RE: **Lot 20 Block 5 Unit 19 SAD 228**  
**7831 Urraca St. NW**  
**Volcano Cliffs Subdivision**  
**Grading and Drainage Plan**  
**Engineers Stamp Date 4/17/2022 (D10D003H20)**

Based upon the information provided in your submittal received 4/12/2022, this plan is approved for Grading Permit.

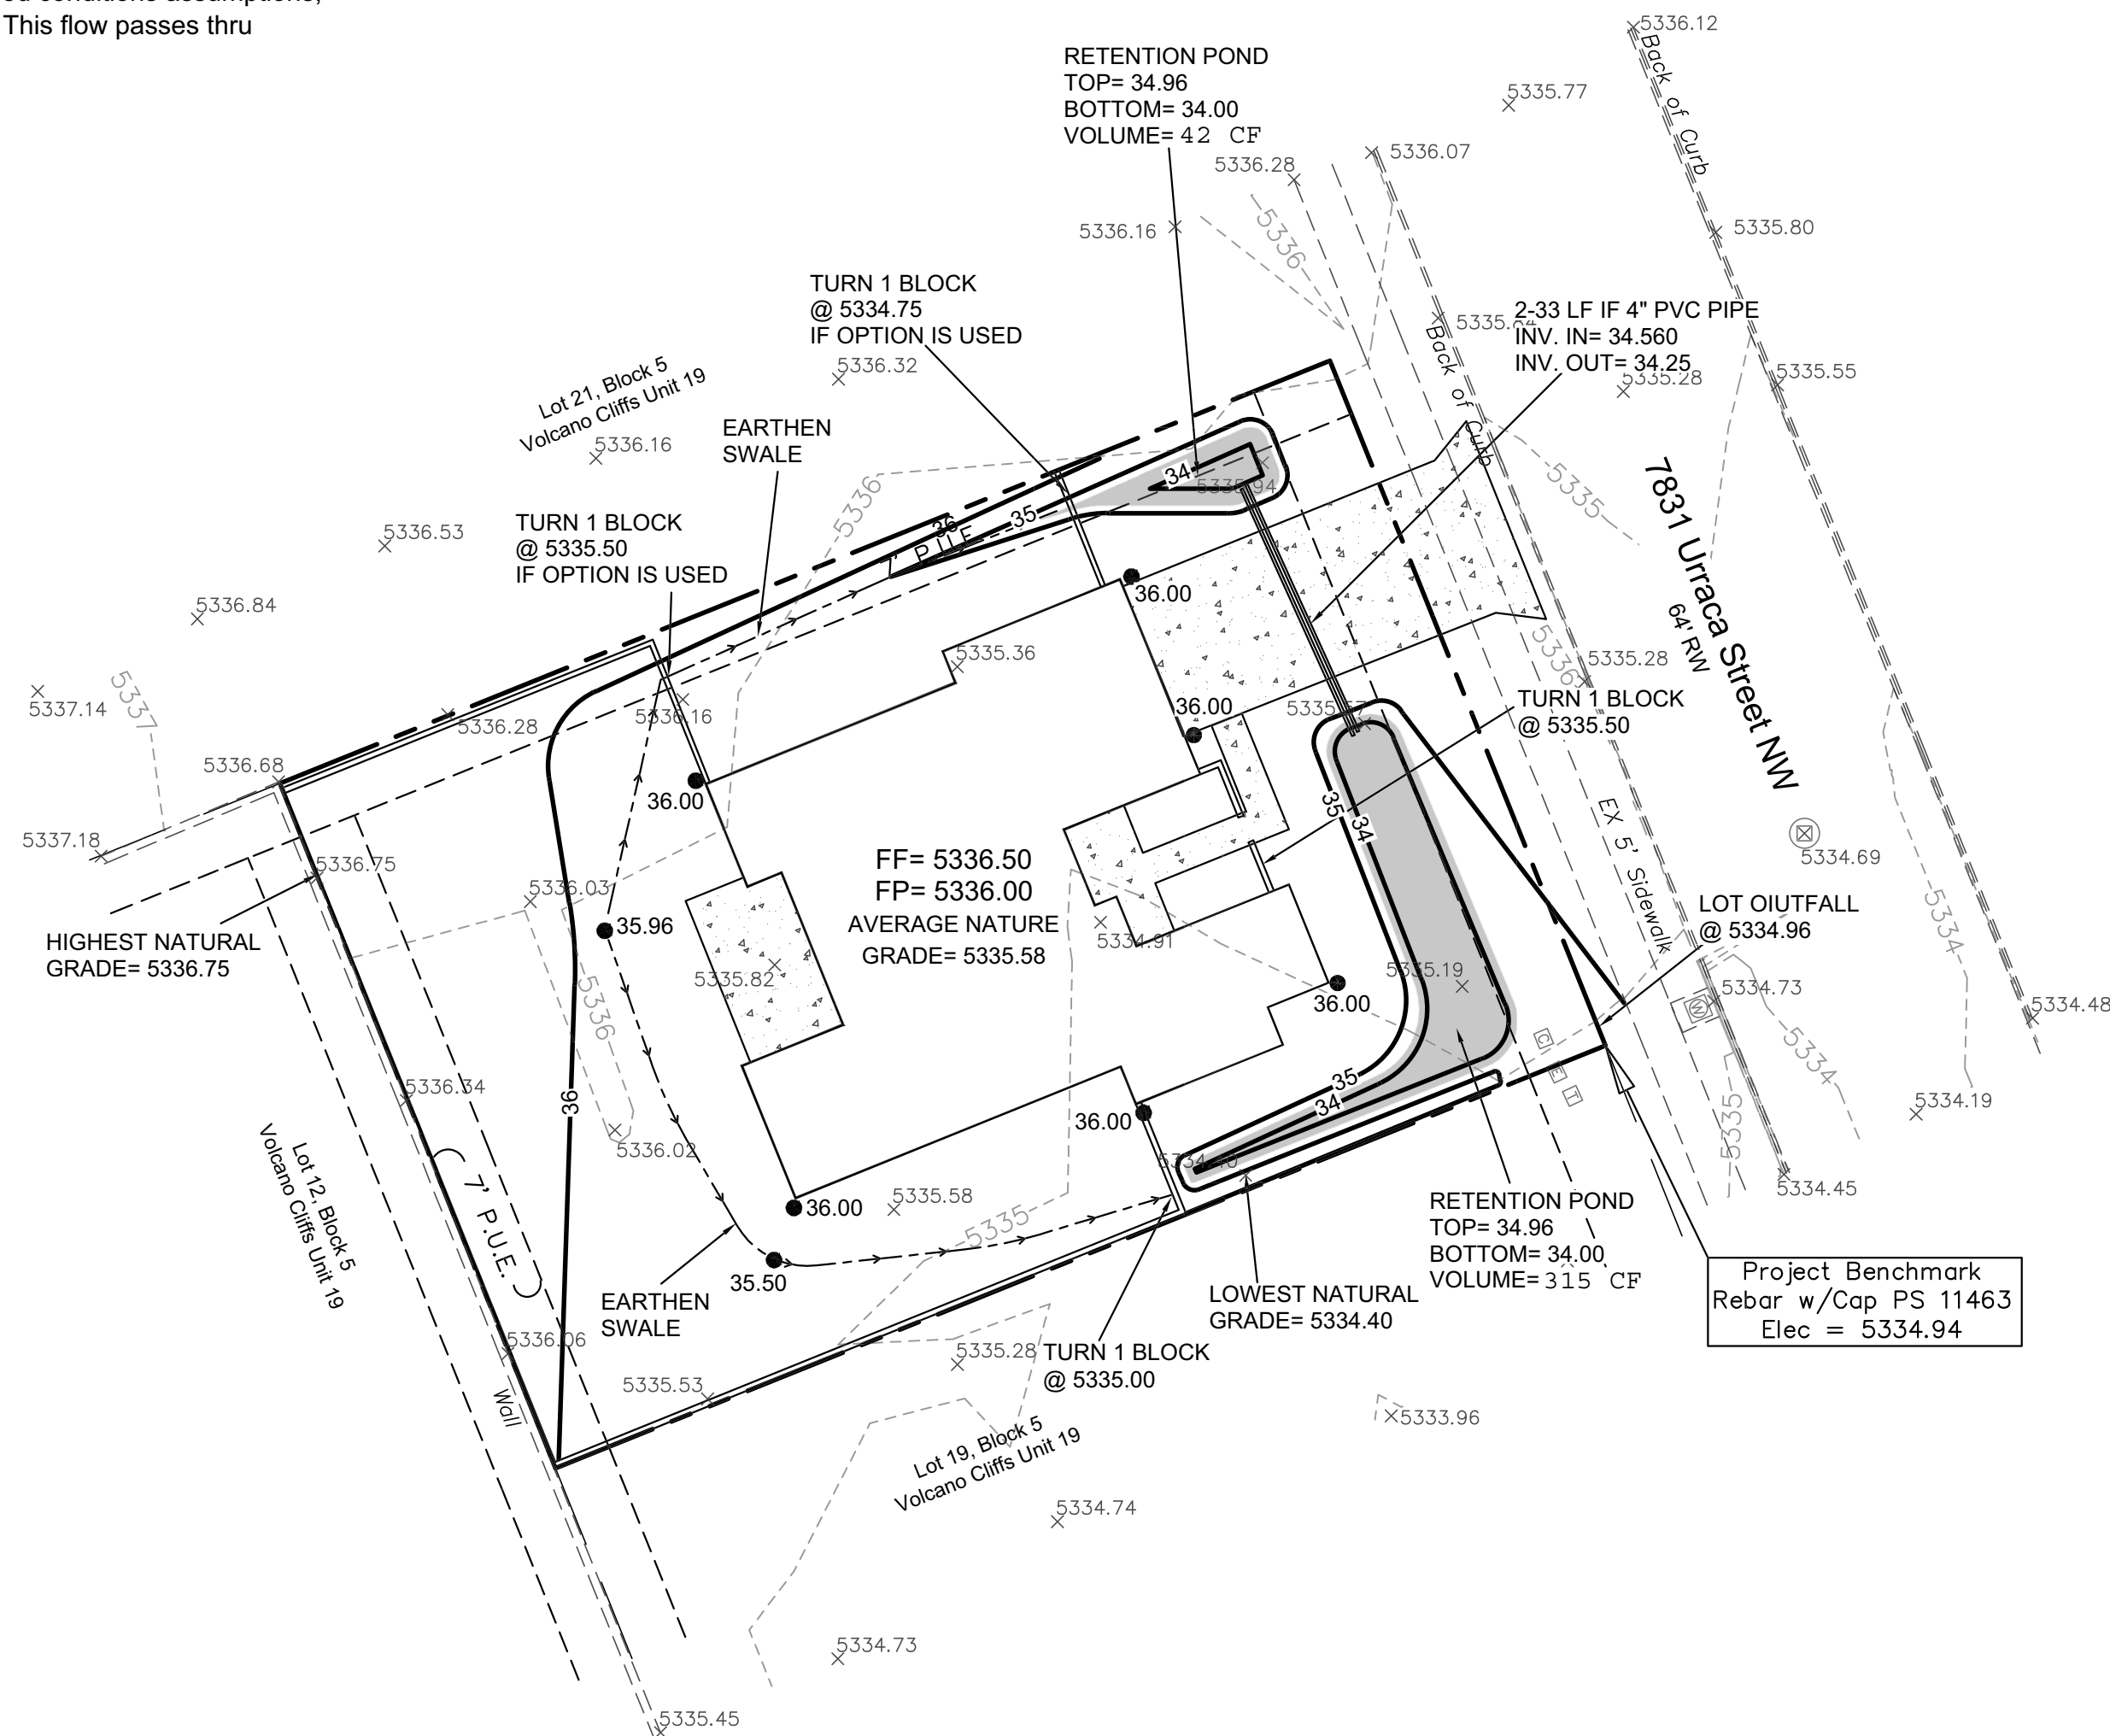
**Advise the owner contractor not to use dirt as a ramp to climb the curb, use lumber or crusher fines for this purpose. Place this note on the plan.**

**Reiterate to the Owner/Contractor that a separate permit for a garden/retaining wall must be obtained with the approved G&D plan and Pad Certification. Also, if a swimming pool is to be placed after this approval a new grading and drainage plan will need to be resubmitted showing the changes for the land treatments.**
